UNITED STATES PATENT AND TRADEMARK OFFICE

| APPLICATION NO. | FILING DATE | FIRST NAMED INVENTOR | ATTORNEY DOCKET NO. | CONFIRMATION NO. |
|-----------------|-------------|----------------------|---------------------|------------------|
| 09/640,038 | 08/16/2000 | Christoph Dorr | TRW(EHR)05042 | 3171 |

Office Action Summary

DETAILED ACTION

2,181,300

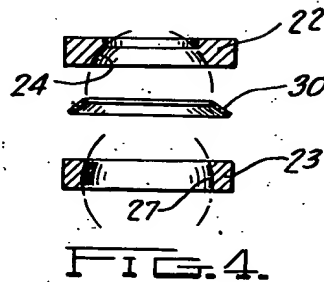
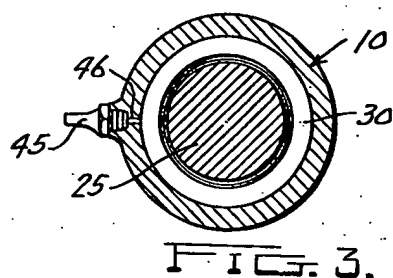
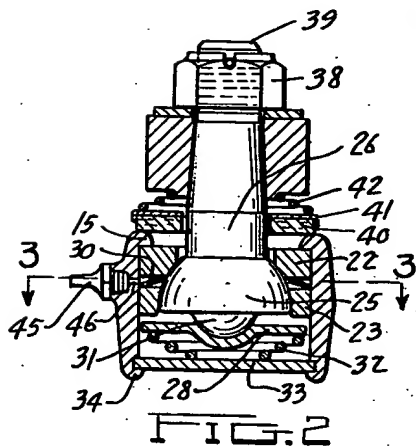
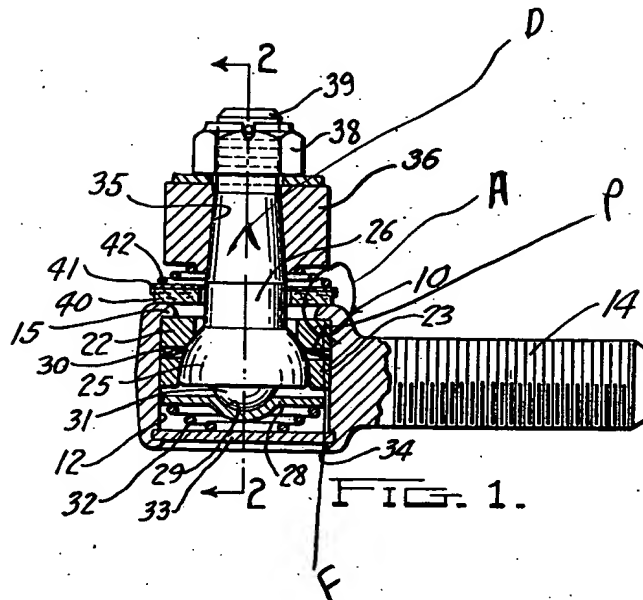
Claims 1, 11, 12 and 16, as best understood, are rejected under 35 U.S.C. 102(b) as being anticipated by Flumerfelt, 2,181,300 (see marked-up attachment).

Regarding claim 1, Flumerfelt discloses in Figure 1 a ball-and-socket joint comprising a joint housing **10**, a ball head **25** with a ball pivot **26**, a bearing shell **22**, and a housing cover **33**. The bearing shell **22** is disposed between the ball head **25** and the joint housing **10**. A compressive force **F** is between the housing cover **33** and at least a portion **P** of the bearing shell **22**. The compressive force **F** permanently acts on the portion **P** and in an axial direction **D**.

Regarding claim 11, the bearing shell **22** is divided into an upper shell **22** and a lower shell **23**.

Regarding claim 12, a spring element **30** is arranged between the upper shell **22** and the lower shell **23**.

Regarding claim 16, an area **A** of the bearing shell **22**, facing in the direction **D**, is preferably cylinder-shaped.
